## **HIRSCH-SHERIDAN SUBDIVISION, UNIT ONE**

### **ADDITION TO**

Engineering Comments: FINAL PLAT COMMENTS (should be addressed prior to submitting the FINAL PLAT for review and/or signature by the City Engineer):

# DETAIL SITE PLAN

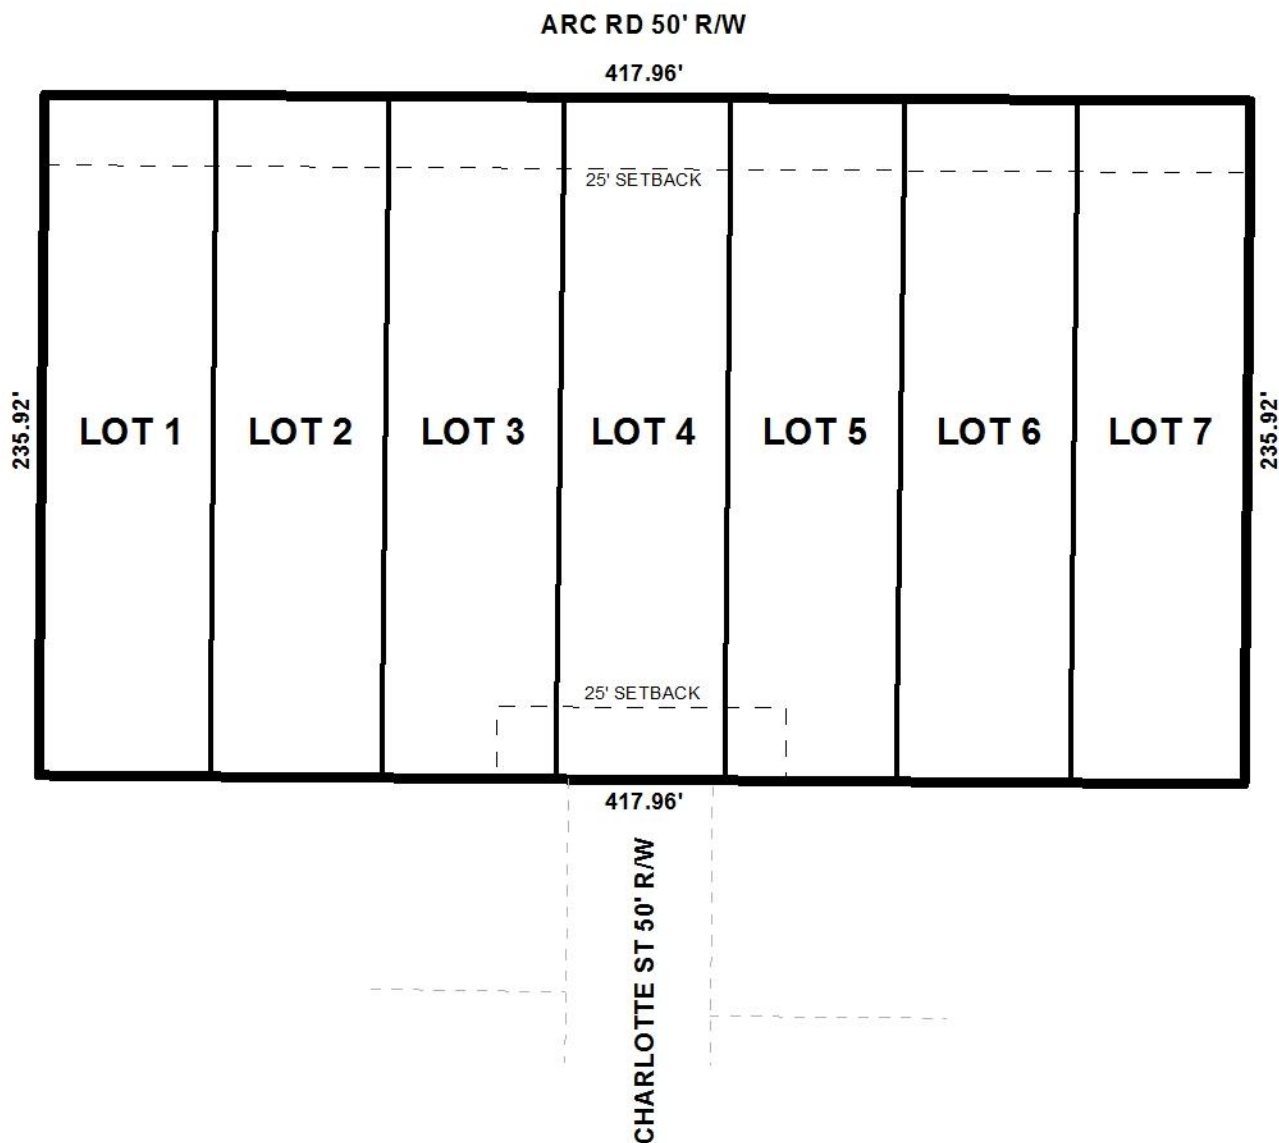
- A. REMOVE THE COUNTY ENGINEER'S SIGNATURE BLOCK FROM THE PLAT. THE COUNTY ENGINEER NO LONGER SIGNS PLATS WITHIN THE MUNICIPAL LIMITS OF THE CITY OF MOBILE.

- B. REMOVE THE MOBILE COUNTY ENGINEERING DEPARTMENT NOTE. THIS PROPOSED SUBDIVISION IS LOCATED WITHIN THE CITY LIMITS. THE COUNTY ENGINEER NO LONGER SIGNS PLATS WITHIN THE MUNICIPAL LIMITS OF THE CITY OF MOBILE.

- C. Provide all of the required information on the SUBDIVISION PLAT (i.e. signature blocks, signatures, certification statements, written legal description, required notes, legend, scale, bearings and distances) that is required by the current Alabama State Board of Licensure for Professional Engineers and Land Surveyors.

- D. National Wetlands Inventory (NWI) mapping, as shown on City of Mobile GIS information, indicates that there is potential for wetlands within the property or properties shown on this plat. Show and label the delineated wetlands, or provide a note that the wetlands shown on this plat are scaled from the NWI data and have not been delineated.

- E. Show and label all flood zones.
- F. Show and label the MFFE (Minimum Finished Floor Elevation) on each lot that contains an AE, V, or X (shaded) flood zone designation.

- G. Provide and label the monument set or found at each subdivision corner.
- H. Add a signature block for the Traffic Engineer.
- I. Provide the Surveyor's, Owner's (notarized), Planning Commission, and Traffic Engineering signatures.

- J. Show the recording information for the vacated easement.
- K. Add a note to the SUBDIVISION PLAT stating that a Land Disturbance permit will be required for any land disturbing activity in accordance with Mobile City Code, Chapter 17, Storm Water Management and Flood Control; the City of Mobile, Alabama Flood Plain Management Plan (1984); and, the Rules For Erosion and Sedimentation Control and Storm Water Runoff Control.

- L. Add a note to the Plat stating that the approval of all applicable federal, state, and local agencies (including all storm water runoff, wetland and floodplain requirements) will be required prior to the issuance of a Land Disturbance permit.

- M. Add a note that sidewalk is required to be constructed, and/or repaired, along the frontage of each lot, or parcel, at time of new development or construction, unless a sidewalk waiver is approved.

- N. Add a note to the plat stating that all easements shall remain in effect until vacated through the proper Vacation process.
- O. Provide a copy of the FINAL SUBDIVISION PLAT to the Engineering Dept. for review. No signatures are required on this drawing.

Traffic Engineering Comments: Each lot is limited to one curb cut per street frontage, with size, location and design to be approved by Traffic Engineering and conform to AASHTO standards.

The preliminary plat illustrates the proposed 6-lot, 1.9± acre subdivision which is located on the South side of Arc Road, ¼ mile±, West of Alba Club Road, extending to the North terminus of Charlotte Street within Council District 3. The applicant states that the subdivision is served by city water and sanitary sewer systems. The purpose of this application is to create six (6) legal lot of record from four (4) legal lots and one (1) metes and bounds parcel. It should be noted that the application states the creation of six (6) lots however; the preliminary play illustrates seven (7) lots.

The proposed lots front Arc Road, a minor street, requiring 50' right-of-way width. The preliminary plat illustrates a 50' right-of-way width for Arc Road and, if approved, should be retained on the Final Plat.

Lot 4 is part of a 50' right-of-way, to be vacated, which abuts the Charlotte Street right-of-way to the South. Charlotte Street is a minor street, with a 50' right-of-way width. If approved, the 50' right-of-way width should be retained on the Final Plat.

A 25-foot minimum building setback line is depicted on the preliminary plat along Arc Road for Lots 1-7. The preliminary plat also illustrates a 25' minimum building setback line where Lots 3, 4, and 5 abut the Charlotte Street right-of-way. If approved, the 25' minimum building setbacks should be retained on the Final Plat.

The proposed lots exceed the 7,200 square foot minimum lot size requirements for lots served by public water and sanitary sewer systems. The preliminary plat provides the lot sizes in both square feet and acres. If approved, the lot size information should be retained on the Final Plat.

As a means of access management, a note should be placed on the Final Plat, if approved, stating that each lot is limited to one curb cut to Arc Road and denied access to Charlotte Street, with size, location and design to be approved by Traffic Engineering and conform to AASHTO standards.

- 1) Completion of the vacation process prior to the signing of the Final Plat;
- 2) Retention of the 25' minimum building setback line along Arc Road;
- 3) Retention of the 25' minimum building setback line where Lots 3, 4 and 5 abut the Charlotte Street right-of-way;

- 4) Retention of 50' right-of-way width for Arc Road;
- 5) Retention of 50' right-of-way width to Charlotte Street;
- 6) Retention of lot size information in both square feet and acres;

- 7) Placement of a note on the Final Plat stating that each lot is limited to one curb cut to Arc Road and denied access to Charlotte Street, with any changes in the size, design and location to be approved by Traffic Engineering and conform to AASHTO standards;
